LESSONS LEARNED

SUMMARY REPORT

Florida Turnpike Enterprise

E8Q92 – Legend

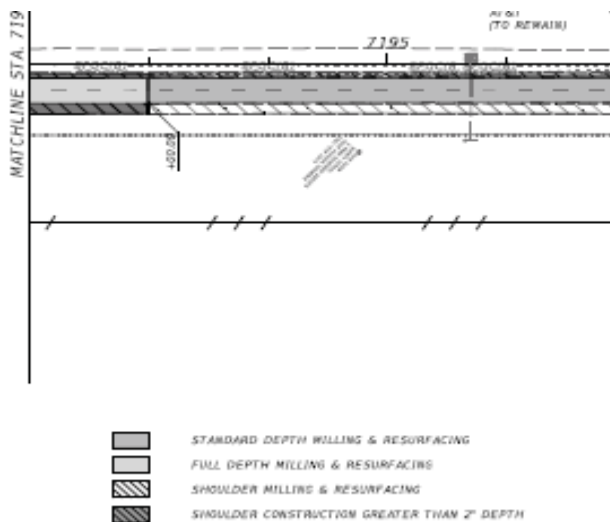
ISSUE SUMMARY: The designer created a Legend to identify differences in milling and resurfacing depths. The Legend identified mainline milling as “Standard” or “Full Depth”, but with 21 milling depths provided in the Plans the Legend led to confusion. This confusion was compounded as the allowable the lane closure times varied based on milling depths.

RESOLUTION: Contractor and CEI worked together to assure work matched the Stationing in the Plans.

LESSON LEARNED: In future Plans, where there are multiple thicknesses for milling and resurfacing, use additional numbering system to depict depths. At least in the Legend, state the range of thicknesses for area being represented. In another project, a box was utilized with a number representing depth and then a leader was shown to the area it represented.

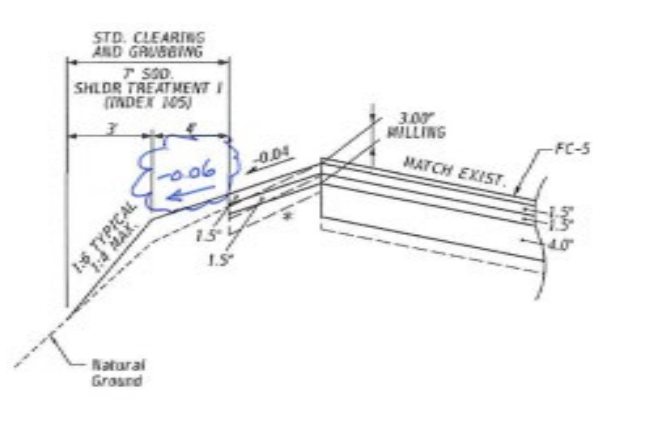
ISSUE SUMMARY: The Contractor submitted an RFI for how covering Rumble Strips would be paid and what satisfies the requirement for covering of the rumble strips. Our initial response that it should be included in the Lump Sum MOT. However, the Estimates Bulletin 14-06 and the most recent Basis of Estimates prohibits temporary asphalt to be paid under Lump Sum MOT and requires the payment through a Special Detour.

RESOLUTION: It was fairly clear that the Contractor did not have enough in the contract under Lump Sum MOT to cover this cost. The cost of covering the rumble strips was handled in a Lump Sum Supplemental Agreement.

LESSON LEARNED: Specify the cost of the of filling in the Rumble Strips under 102-2 Special Detour (Lump Sum). The plans should not quantify temporary asphalt tonnage; however, the Plans need to provide width, length, and thickness information so that the Contractor knows the work required by this Special Detour.
